Towards Consensus on MPI Penalty for 802.3bs SMF PMDs

Addressing Comments: 133-142

Comments addressed against 802.3bs D1.2

400GBASE-DR4 (500m)

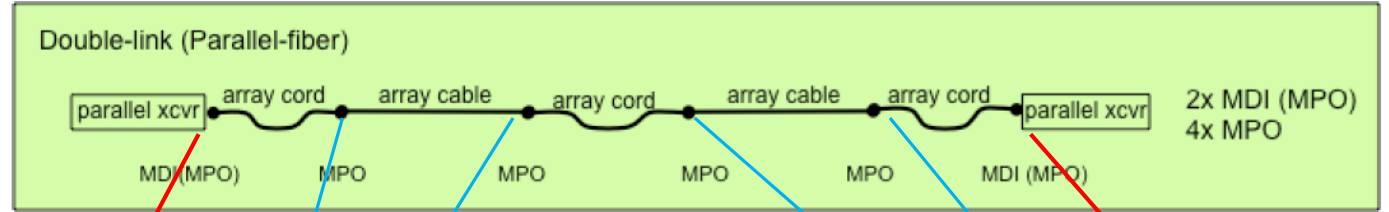
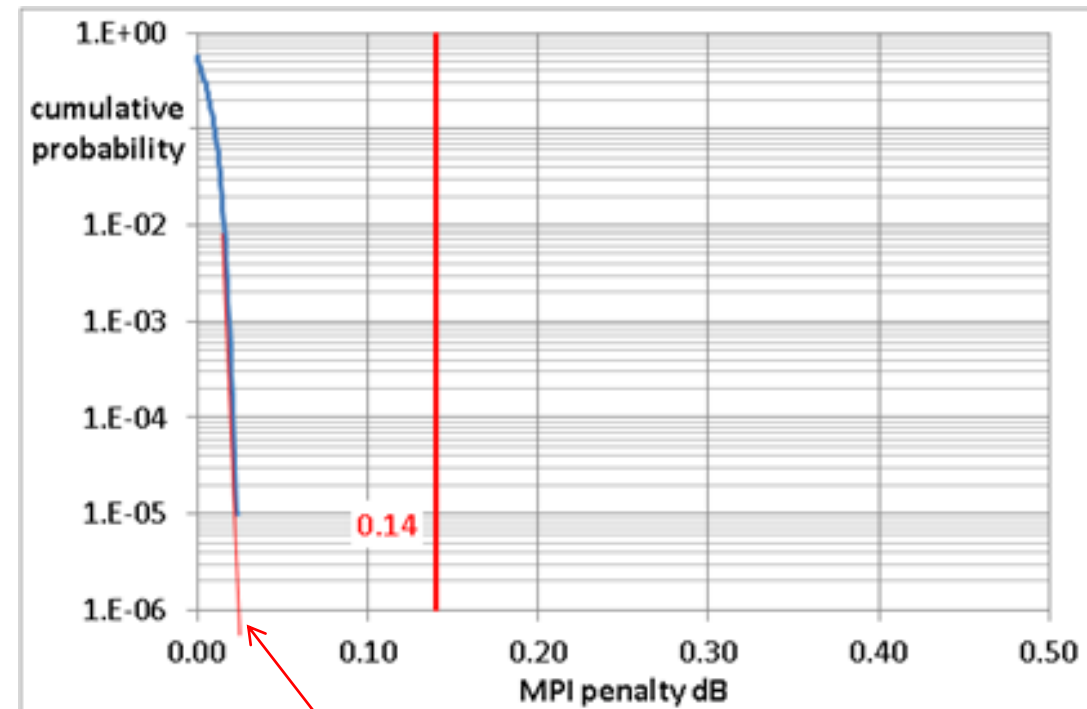
Round up MPI penalty from 0.03dB to 0.1dB to include in the link budget.

0.03dB

400GBASE-DR4: MPI Penalty with 45 dB MPO RL

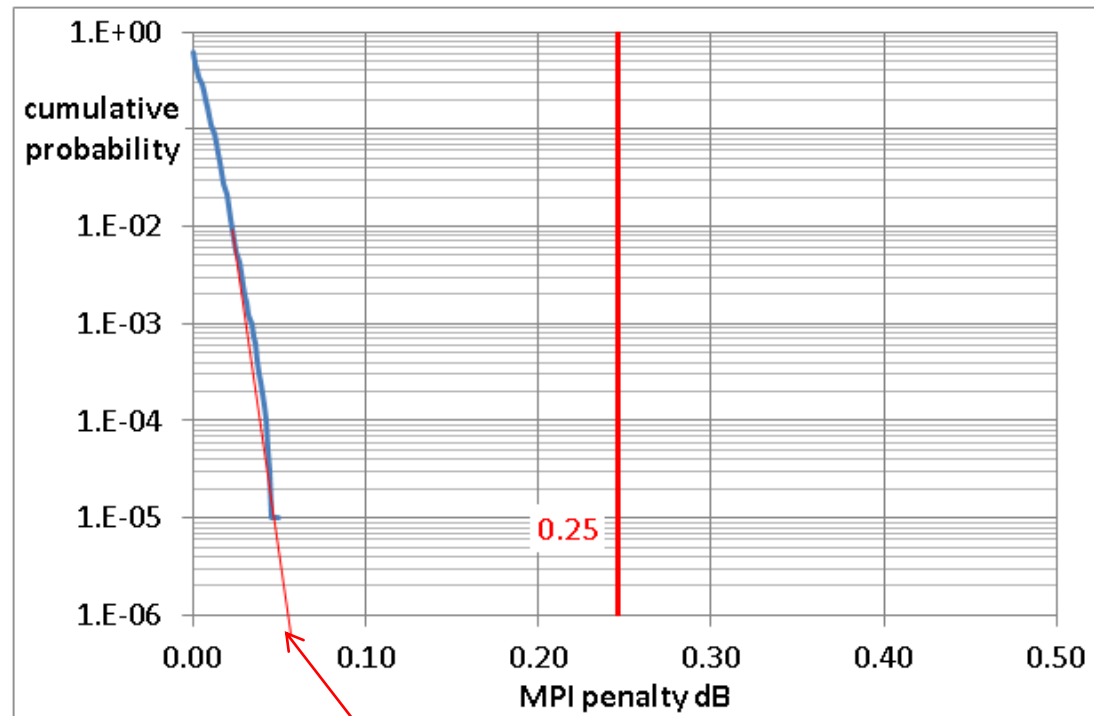
< 0.1 dB MPI penalty is still ensured even when the MPO RL is 45 dB.

Therefore, plan to use -45dB for the maximum discrete reflectance in the DR4 link budget table.

400GBASE-FR8 (2km)

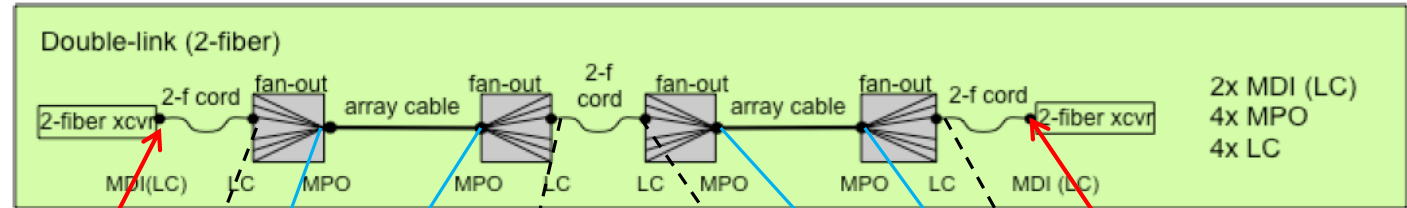
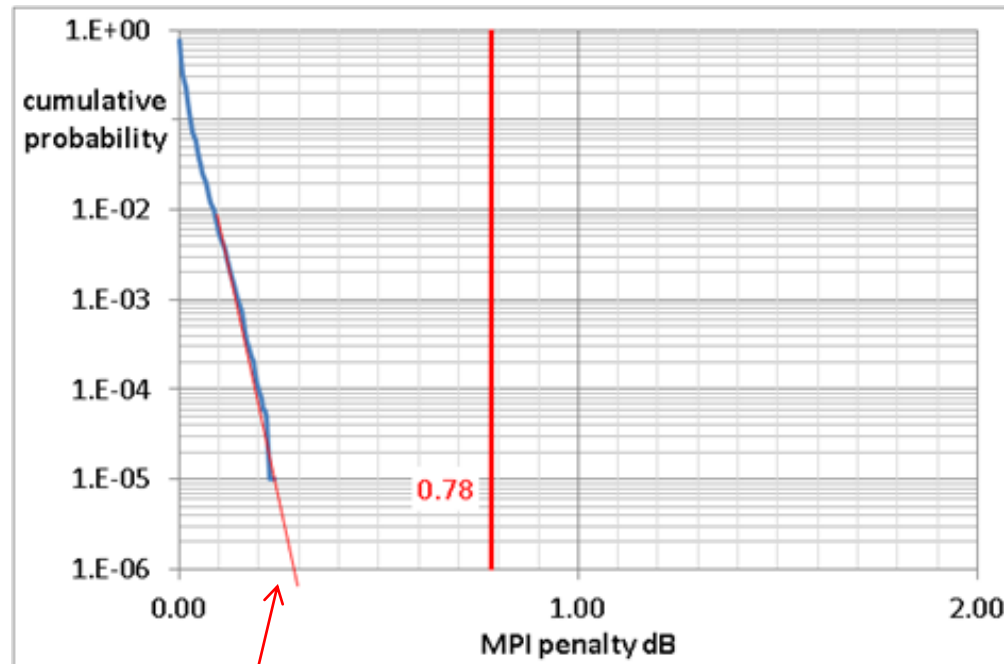
Recommend to include 0.3 dB MPI penalty into the link budget.

0.3 dB

400GBASE-LR8 (10km)

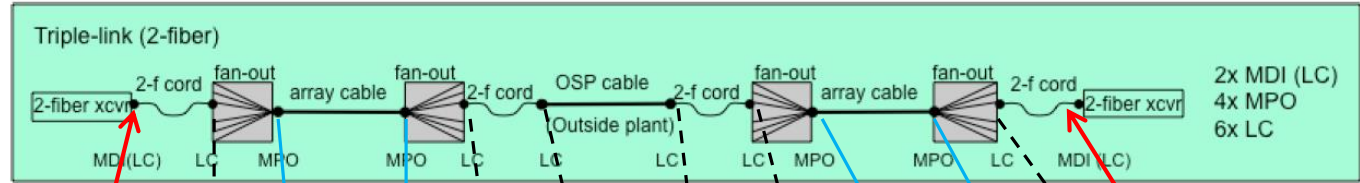
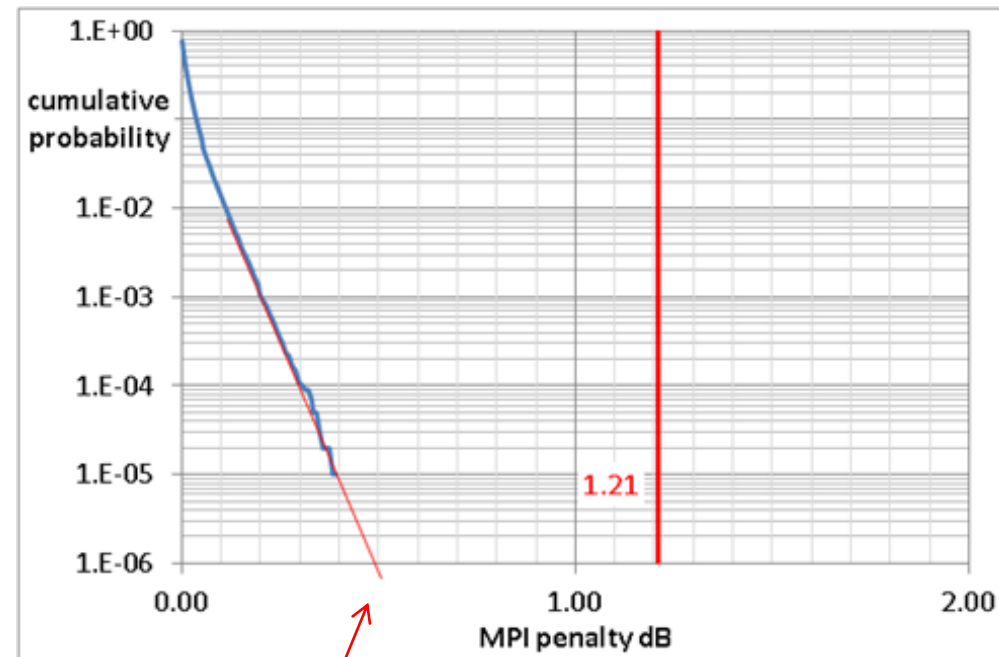
0.5 dB

Recommend to include 0.5dB MPI penalty into the link budget.
